## Error Estimate on AC Loss Measurement Parameters

Figure 1

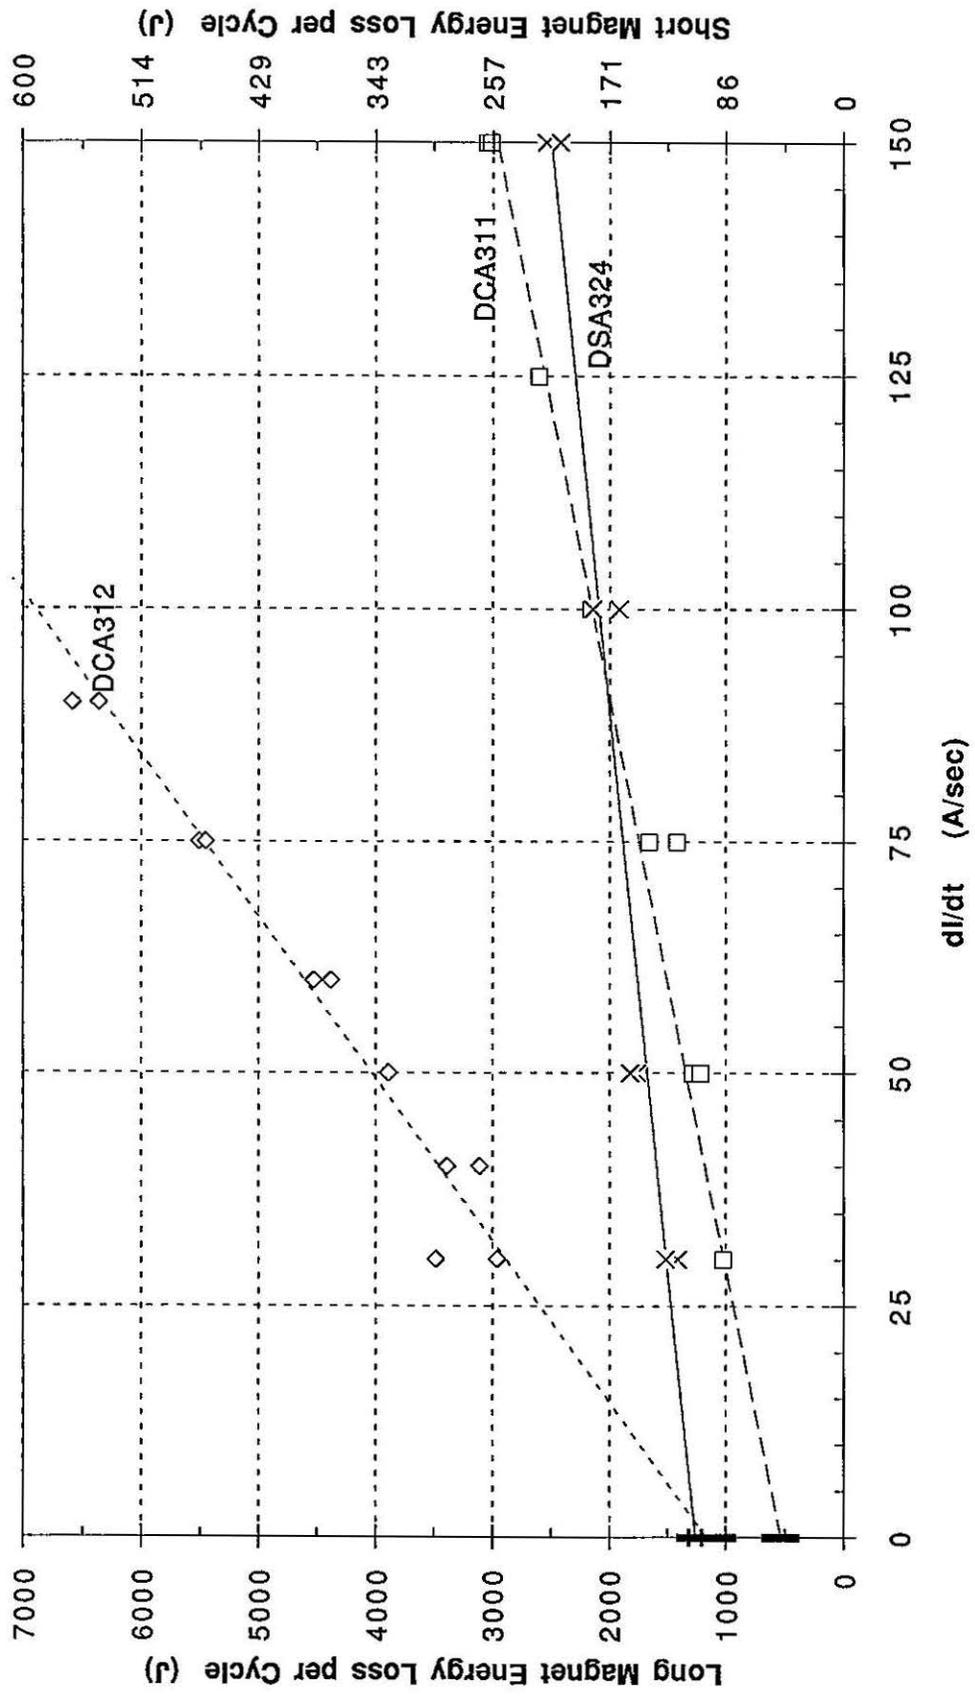
The linear least squares fitting routine in Microsoft Excel returns the standard estimate of error for each of the fit coefficients. I have used Excel to refit the data and find the errors. The data are reproduced in Table I for DSA324, DCA311 and DCA312. For the long magnets the "corrected" data from [4] are used, and for the short magnet uncorrected data from [3] has been used. (It is believed that no correction is required for the short magnet data. For the long magnets the corrections range from 6-8% at the lowest ramp rates to <1% at the highest ramp rates measured.) Below the data for each magnet are the fit slopes and intercepts and below them the error estimates. Shown also, labeled "sig( $E_{corr}$ )," are the standard error estimates for the energy loss measurements. The latter is the rms deviation of the measured from the fit values, where the summed squared deviation is divided by the number of data points minus 2. Figure 1 plots the data for the three magnets along with the fits. To facilitate the comparison between the short and long magnets, the short magnet data is plotted against the right axis, whose scale differs by a factor of 11.7, roughly the ratio of magnetic lengths, from the left scale. The heavy solid bars along the left axis show the  $\pm 1$  standard deviation bands for the fit values of  $E_0$  for the two long magnets, and the two heavy tic marks show the same for the short magnet.

It is clear that the errors on the long magnet data are considerably larger in proportion to the magnet length than those on the short magnet data. The hysteresis losses measured in DCA312 and DSA324 are compatible, but DCA311 is significantly lower. The difference in  $E_0$  between DCA312 and DCA311 is  $630 \pm 255$  J. The result from DSA324, scaled by 11.7, predicts a long magnet  $E_0$  of  $1265 \pm 55$  J. The difference between this and the DCA311 result is  $730 \pm 140$  Joules. This difference is more than 5 standard deviations and is therefore statistically significant. Of course, examination of Figure 1 makes it clear that the data from DCA311 and DSA324 are significantly different.
